# Access Compliance Report

## Public Rights-of-Way (Curb Ramps)

Intersection ID: 51509	Main Street: EASTFIELD_PARK_DR	Cross Street: NETHERTON_LN	Location:	N
ADA ID: 8AF901C04A2D	Ramp Type: PerpDiag	Initial Pass/Fail: Fail	Overall Compliance: No	Severity Score: 10

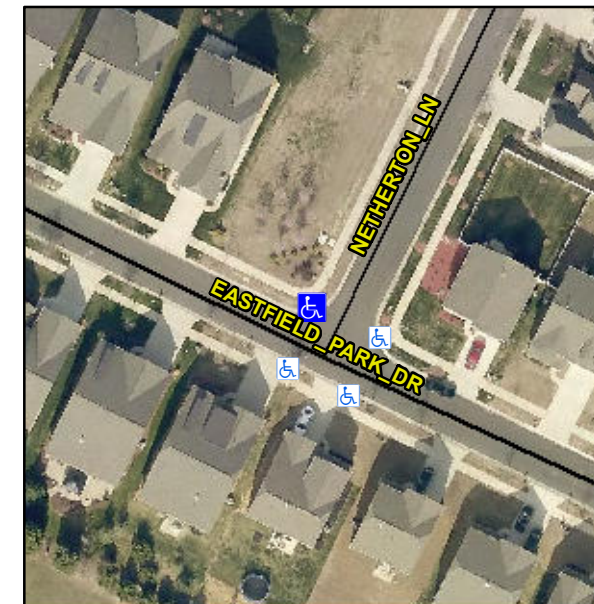
**Not Found, R304.5.1, R304.5.3**

Compliance	Description	Data	Compliance	Description	Data
N/A	Ramp Length (in)	71.0	Yes	Ramp Slope (%)	6.7
No	Ramp Width (in)	47.5	No	Ramp XSlope (%)	4.2
N/A	Flare Type LT	N/A	N/A	Flare Type RT	N/A
N/A	Flare Slope LT (%)	N/A	N/A	Flare Slope RT (%)	N/A
N/A	Flare Traversable LT?	N/A	N/A	Flare Traversable RT?	N/A
N/A	Landing Length (in)	N/A	N/A	DWS Provided?	N/A
N/A	Landing Width (in)	N/A	N/A	DWS Contrast?	N/A
N/A	Landing Slope (%)	N/A	N/A	DWS Length (in)	N/A
N/A	Landing X Slope (%)	N/A	N/A	DWS Full Width?	N/A
N/A	Landing Curb? (Y/N)	N/A	N/A	DWS Offset (in)	N/A
N/A	Shared Landing?	N/A			
N/A	Gutter Ponding?	N/A	N/A	Gutter Slope (%)	N/A
N/A	Gutter Lip Ht (in)	N/A	N/A	Gutter X Slope (%)	N/A
N/A	Painted X Walk1?	No	N/A	Painted X Walk2?	No
	X Walk 1 Direction	To SW		X Walk 2 Direction	To SE
N/A	X Walk 1 Width (in)	N/A	N/A	X Walk 2 Width (in)	N/A
	X Walk 1 Slope (%)	4.7		X Walk 2 Slope (%)	3.5
	X Walk 1 X Slope (%)	0.8		X Walk 2 X Slope (%)	4.7

**Remove & Replace Curb Ramp With Two New Directional Ramps or Equivalent.**
